# Carmel Clay Schools – West Clay Elementary School Walking Path Re-Quote Carmel, IN 46033

## **TO: ALL QUOTING CONTRACTORS OF RECORD**

This Addendum consists of Pages ADD 1-1, Updated Proposal Form with Addendum Information, Fanning Howey Associates Addendum No. 1 – Drawing G1.0 dated April November 9, 2021 consisting of 1 page.

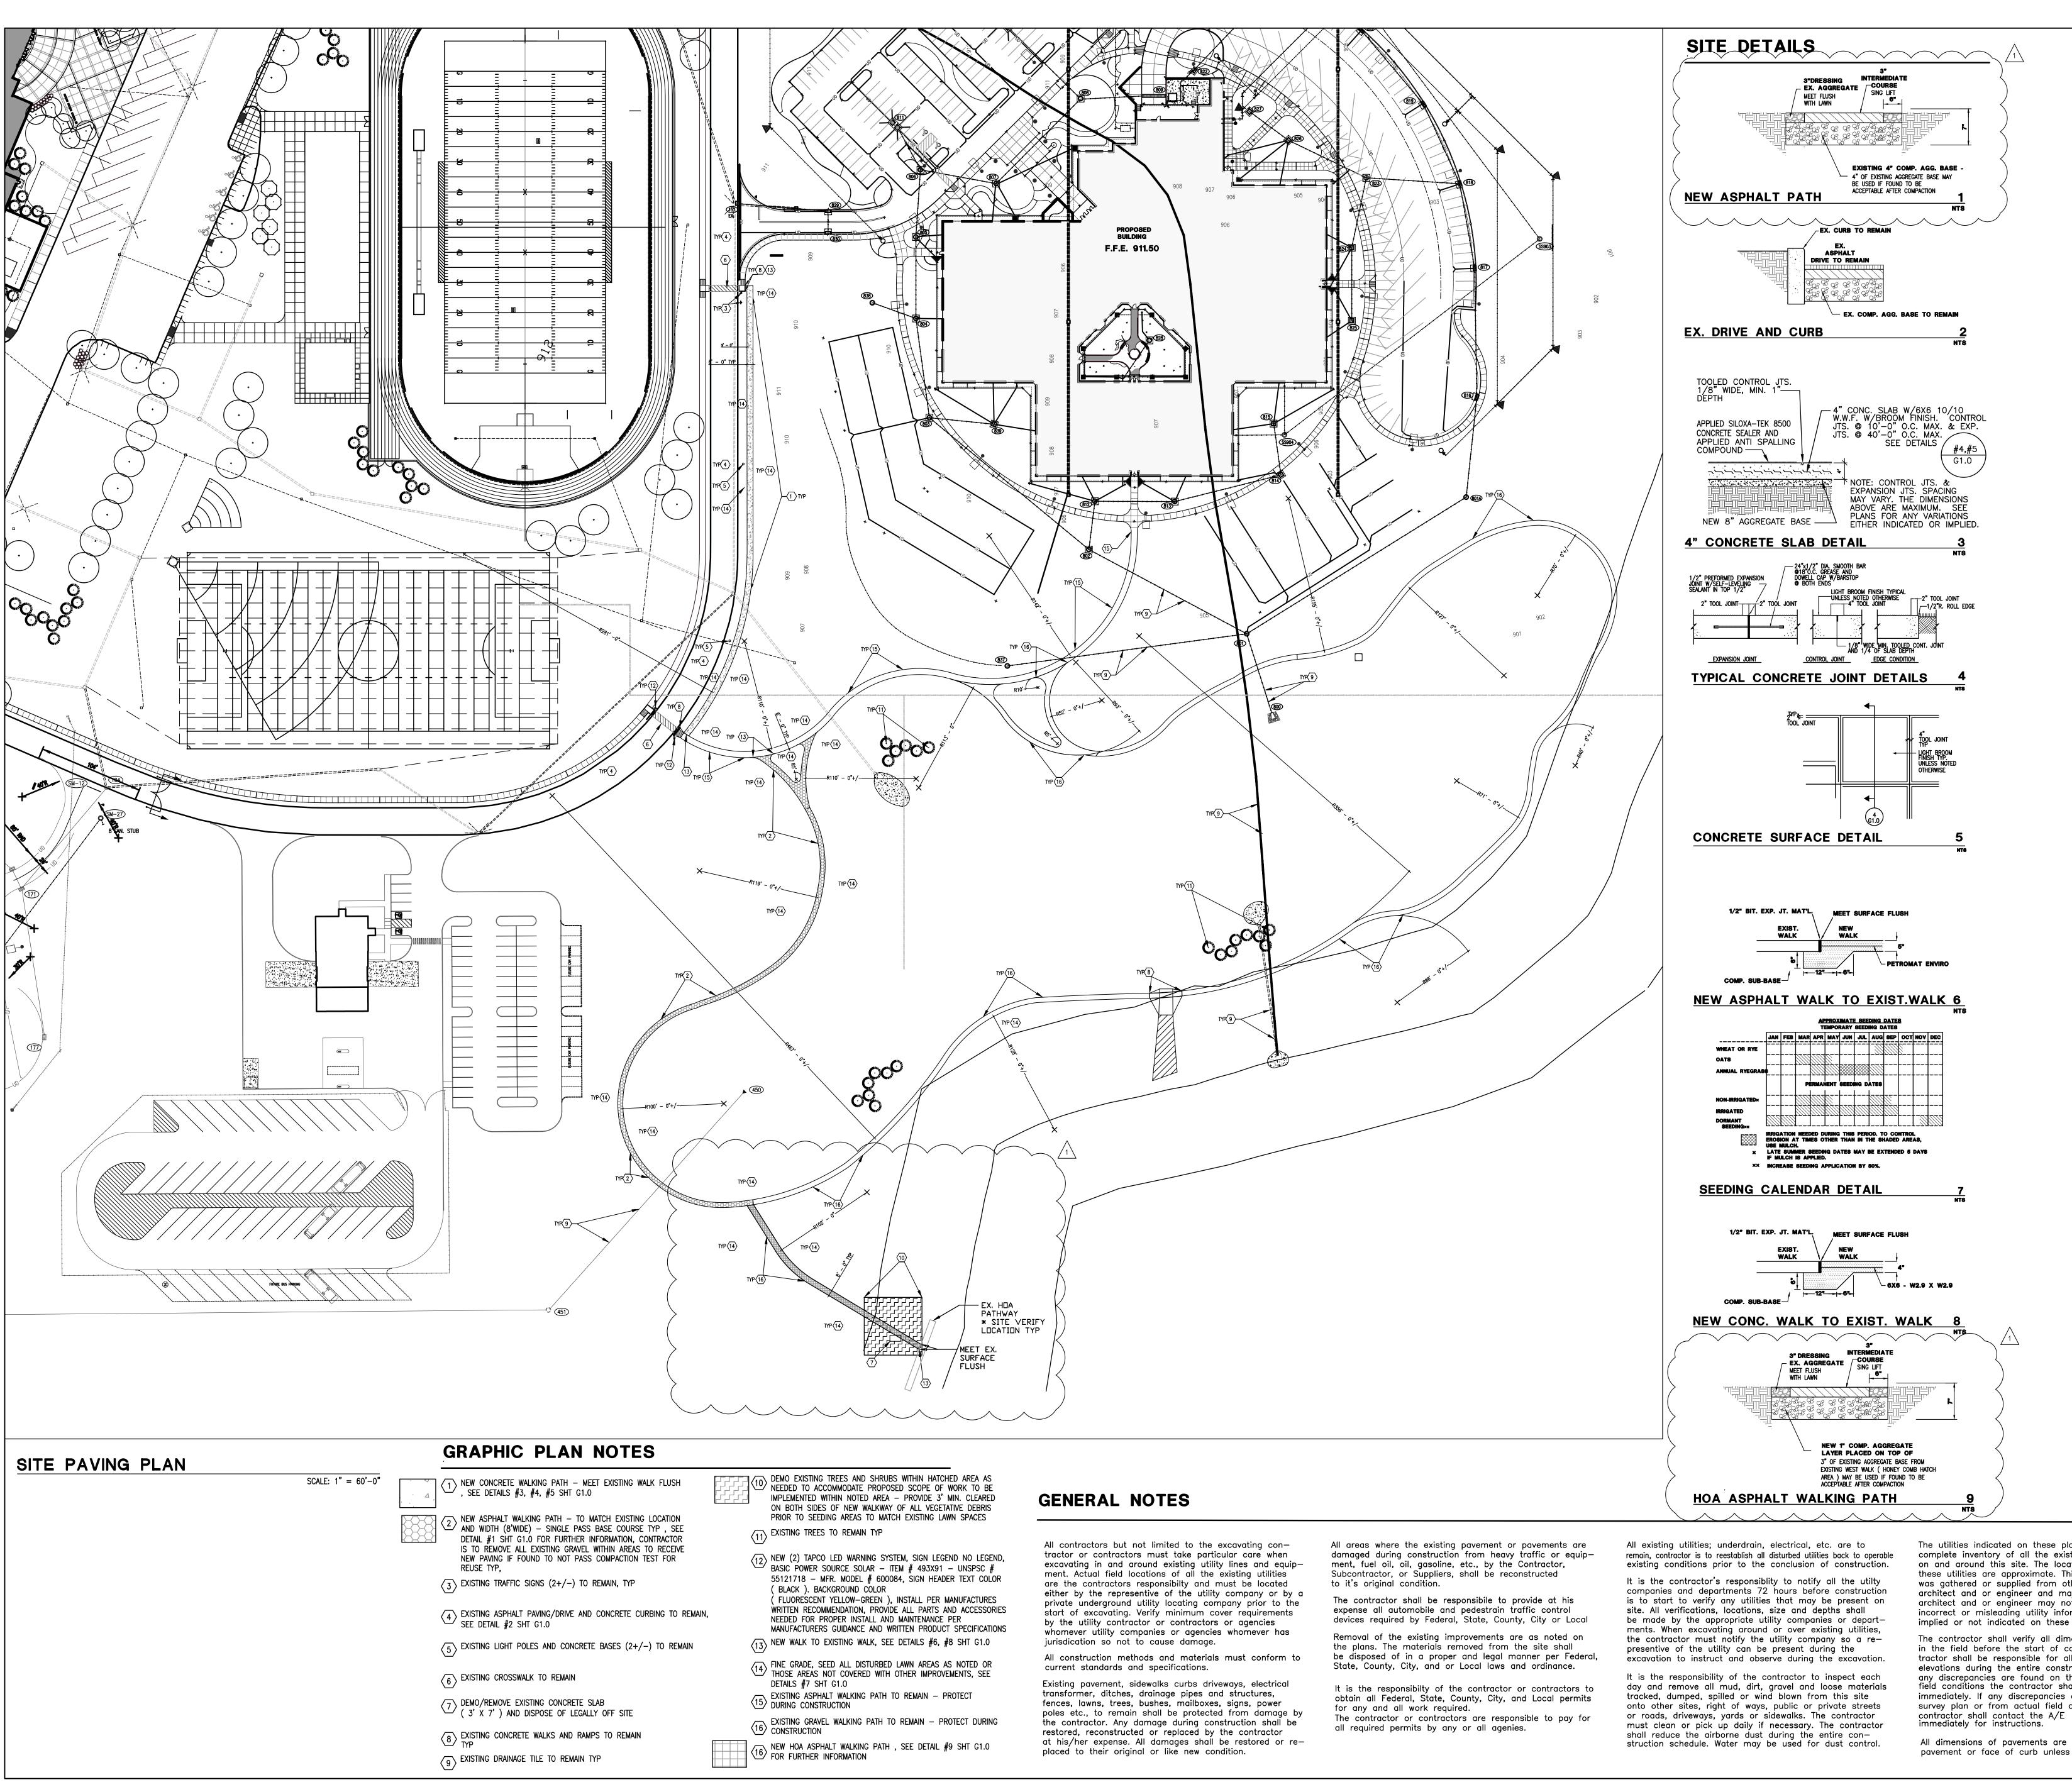
Alternate No. 01: Provide new *Concrete Multi-Use Paths* five feet wide in lieu of the new asphalt walking paths detailed in Graphic Plan Notes #2 & #16. Refer to Drawing G1.0 / Detail 3 for the 4" Concrete Slab Detail to be matched for this alternate.
